***Design Review Board Case #2019-0007
Hoffman Town Center – Blocks 4 & 5 West Tower***

Application	General Data	
Project Name: Hoffman Town Center Blocks 4 & 5 West Tower Location: 2410 and 2460 Mill Road Applicant: HTC 4/5 Project Owner, LLC	DRB Date:	July 18, 2019
	Site Area:	5.07 acres (220,940 sf)
	Zone:	CDD#2
	Proposed Use:	Residential, Retail
	Gross Floor Area:	1,021,711 sf
Purpose of Application:		
DRB review and approval of architectural changes to the West Tower in the Hoffman Town Center mixed-use retail and residential complex.		
Staff Reviewers: Robert Kerns, AICP, robert.kerns@alexandriava.gov Thomas H. Canfield, AIA tom.canfield@alexandriava.gov Nathan Imm, nathan.imm@alexandriava.gov Bill Cook, william.cook@alexandriava.gov		
DRB ACTION, JULY 18, 2019: The DRB voted unanimously 3-0 to approve the proposed architecture revisions conditioned upon the further alteration of the façade architecture per staff’s recommendations in the staff report. Motion presented by Mr. Quill, seconded by Mr. Lewis, Councilwoman Pepper absent. The applicant agreed that the issues outlined by staff in the analysis section could be addressed. In addition to those issues, the applicant and

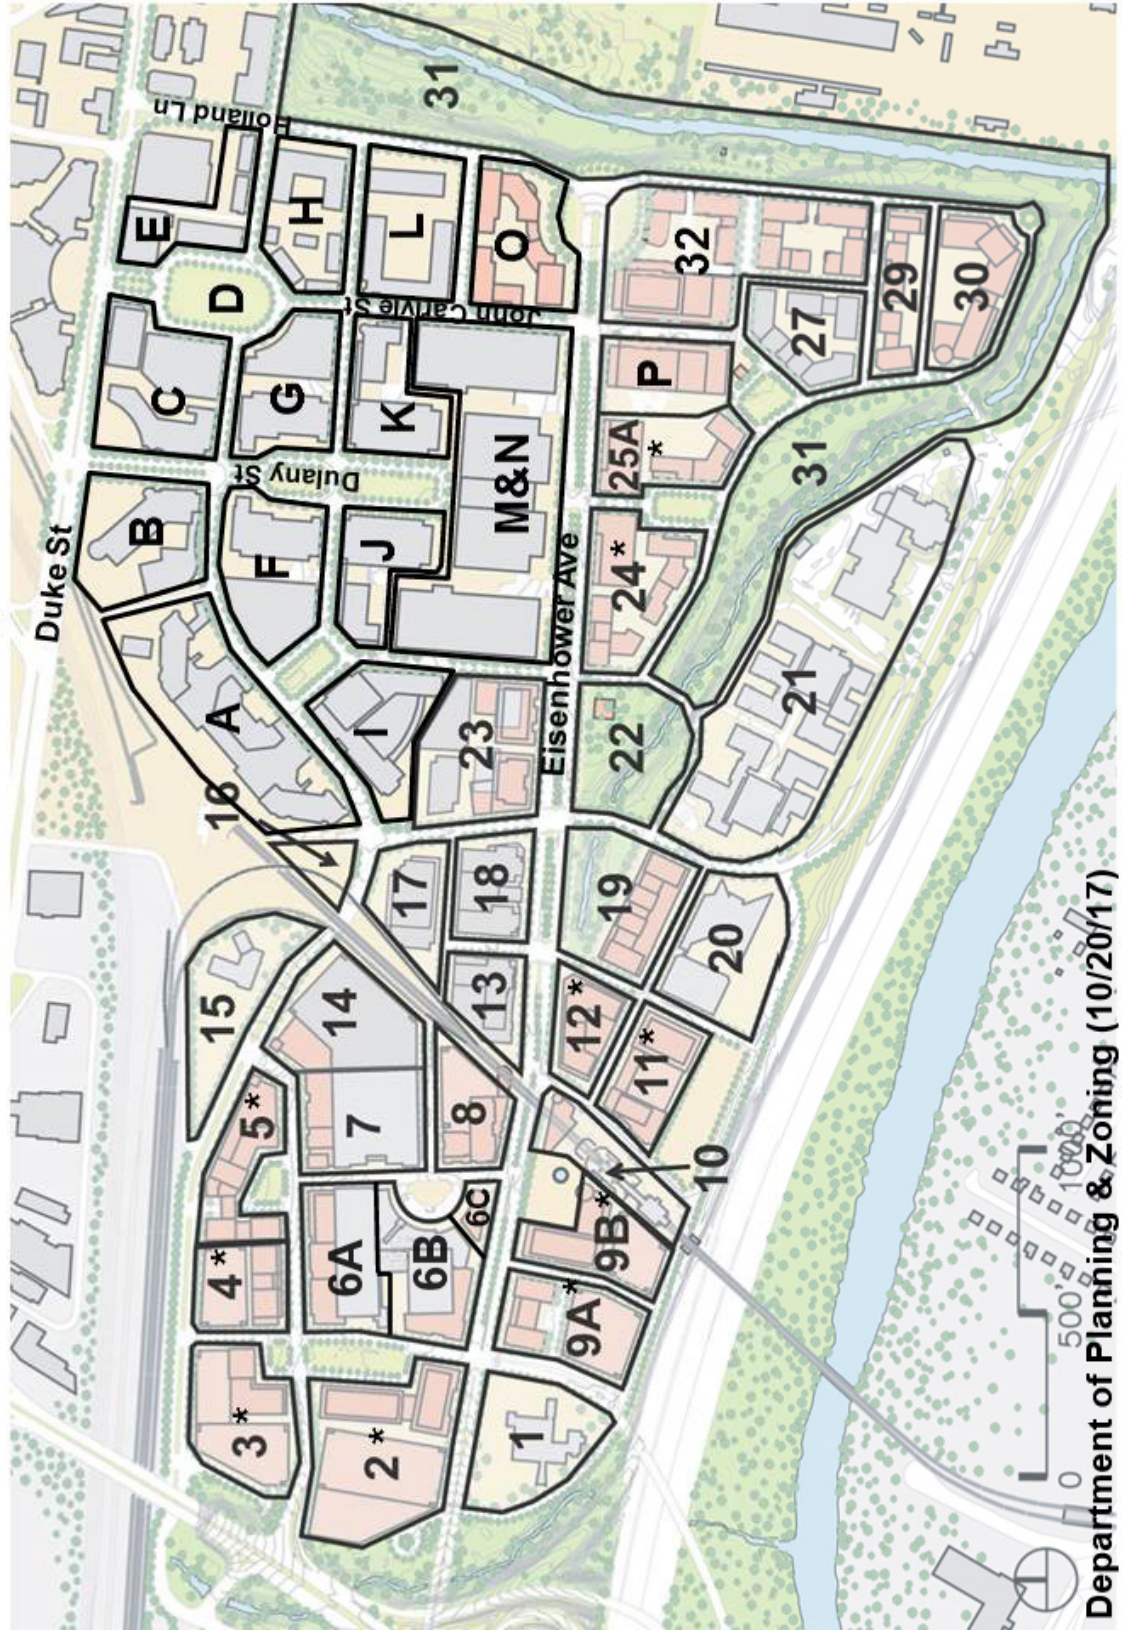
1. Use light colored brick instead of dark on the south wall connecting the feature with the main tower. This further differentiates this feature and would make it consistent with the brick treatment used on the corresponding north side.

2. Within the south wall, include fenestration, spandrel glass, or some other form of recesses, possibly in multi-story groupings, to decrease the appearance of a solid wall, and recall the windows in the approved design. The larger expanse of blank wall appears out of context in the building massing.

3. Consider ways to visually extend the garage opening vertically so there is the appearance of less solid wall between the garage opening and the openings above at levels P4 and P5. The garage opening as depicted appears compressed, as if the huge mass of masonry above is pressing down on it.

4. Consider architectural treatment to the P4/P5 opening in order to reduce the appearance of a two-level void. Formerly this area was glazed and made a stronger connection to the street.

5. Study adjusting the north wall adjacent to Unit Type A far enough north to eliminate the need for the "inner liner" in the vertical feature. This might allow making this unit tier big enough to re-introduce windows in the south-facing wall in the bedroom (as discussed in comment 2 above.)

6. Elevations now show floors with shadow-boxes at the 4th and 5th levels. Staff believes that the extra height that was previously shown within the corner glass element is important to the visibility of the anchor tenant, for interrupting the podium appearance, and is a good

opportunity for visual reinforcement of the anchor tenant. Reinstate the open design as originally approved.

7. Clarify the glazing and/or resolve the inconsistent color rendering of the first column bay north of the grocery entry along Stovall Street.
